February 10, 1987

SUBJECT: COMANCHE PEAK STEAM ELECTRIC STATION (CPSES)
DOCKET NOS. 50-445 AND 50-446
REQUEST FOR INFORMATION REGARDING INSPECTION REPORTS:
50-445/85-07, 50-446/85-05; 50-445/85-14, 50-446/85-11;
50-445/85-16, 50-446/85-13; 50-445/86-06, 50-446/86-04

SUPPLEMENTAL REQUEST FOR INFORMATION REGARDING
INSPECTION REPORTS
50-445/85-07, 50-446/85-05; 50-445/85-14, 50-446/85-11;
50-445/85-16, 50-446/85-13; 50-445/86-06, 50-446/86-04

FOR INFORMATION ONLY

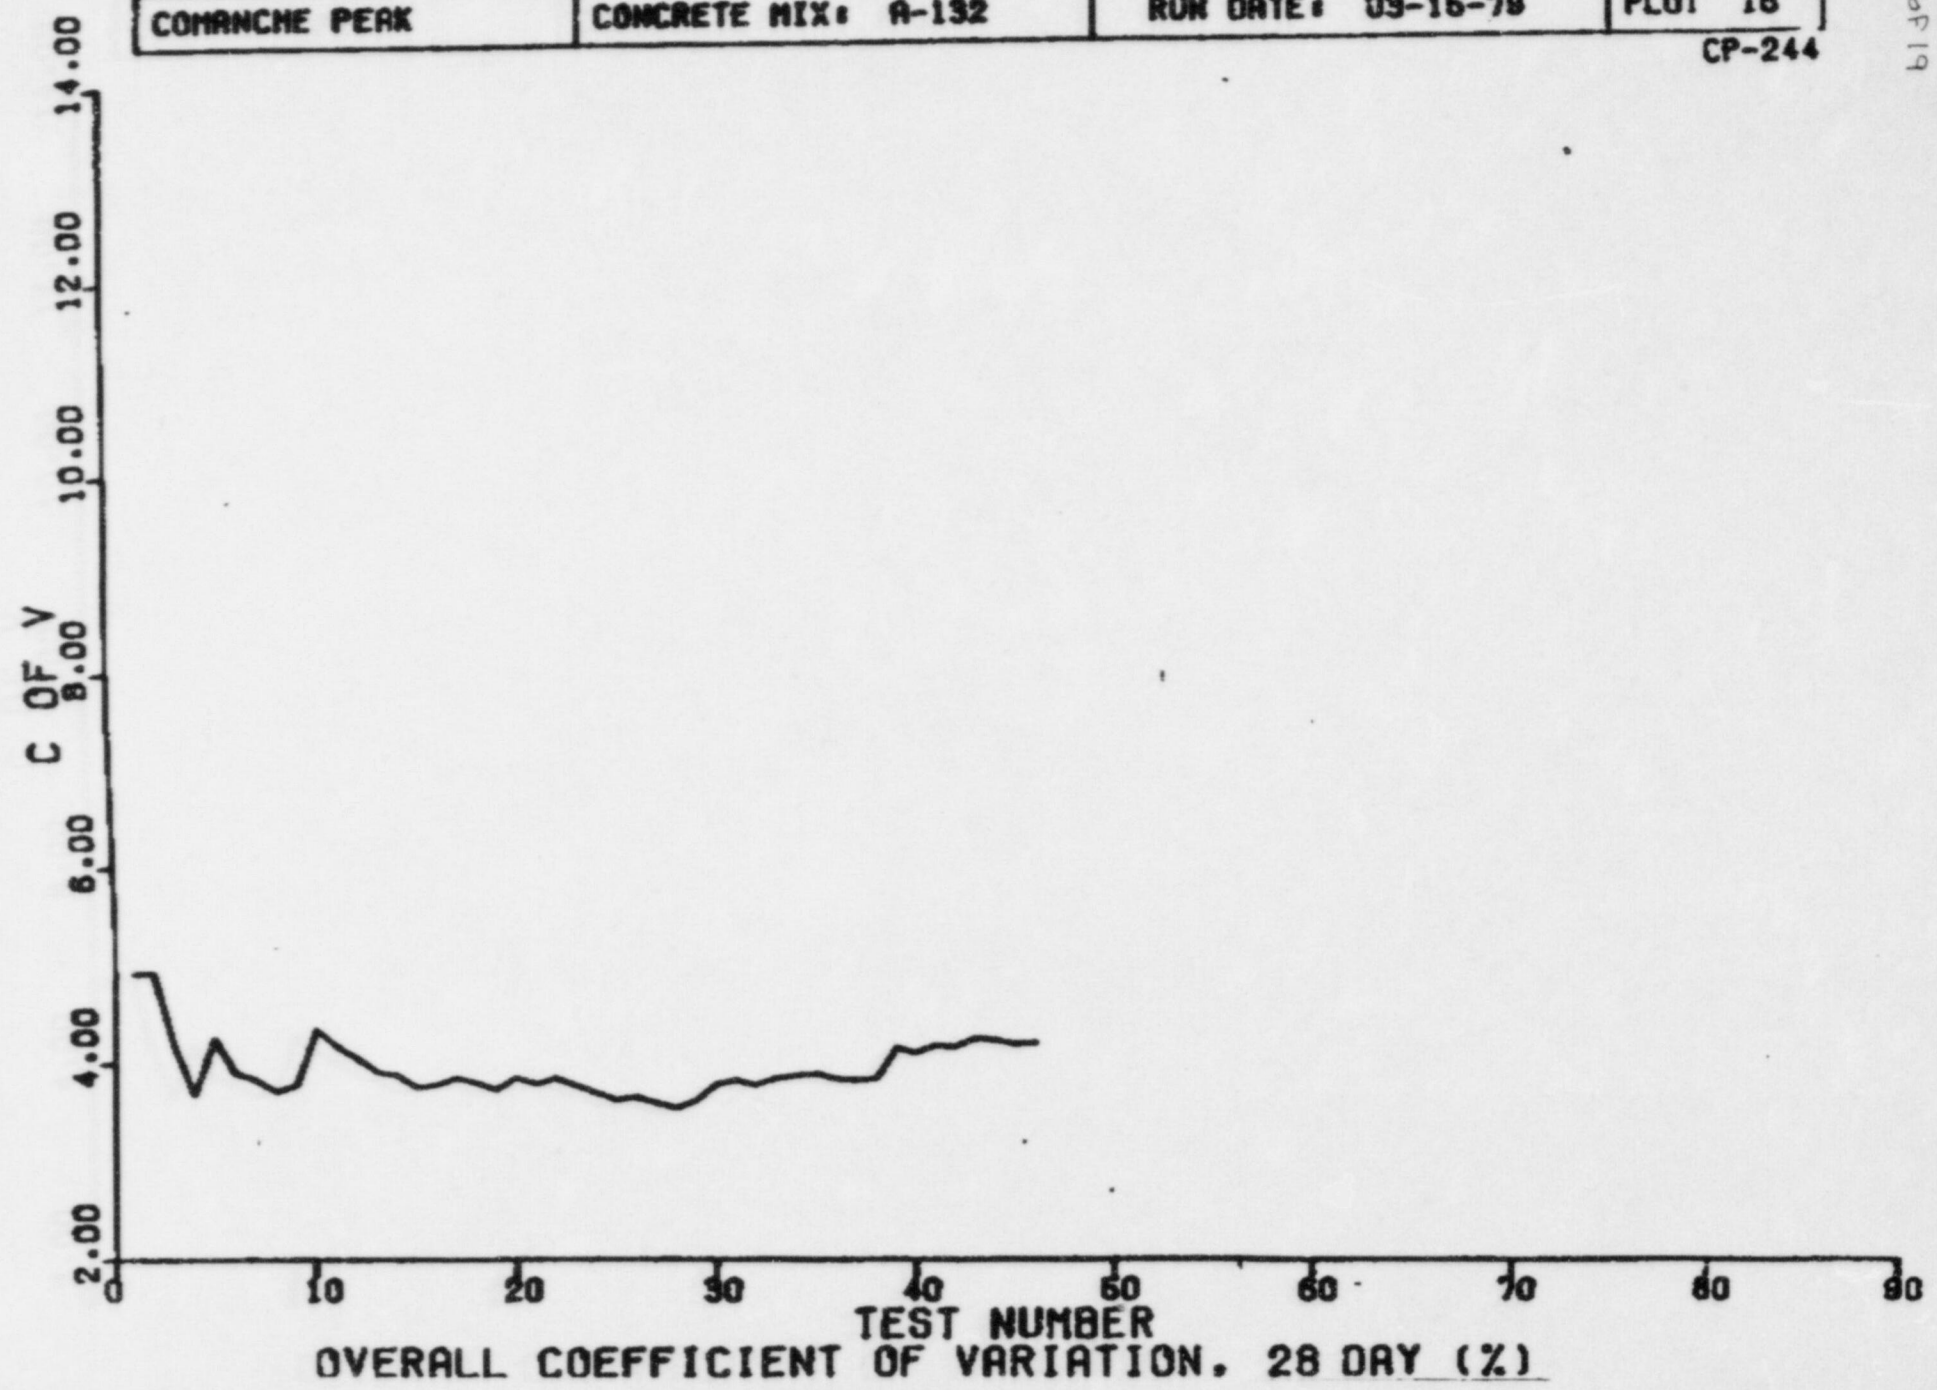
4. With reference to inspection report 50-445/85-07, 500-446/85-05, and NOV 445/8507-04, 446/8505-02, although no records exist that concrete mixing blades had been inspected quarterly since trucks were placed in service in 1977, it is our understanding that there are consistent concrete strength and uniformity tests.
 - a. Does TU Electric have a concrete strength statistical distribution for this period?
 - b. Provide three (3) results reports spaced over this period (i.e., 1977, 1980 and 1984).

Enclosure 1 is a statistical evaluation of a series of concrete tests run during 1978. This is one of several statistical evaluations run during the 1973 to 1979 time frame.
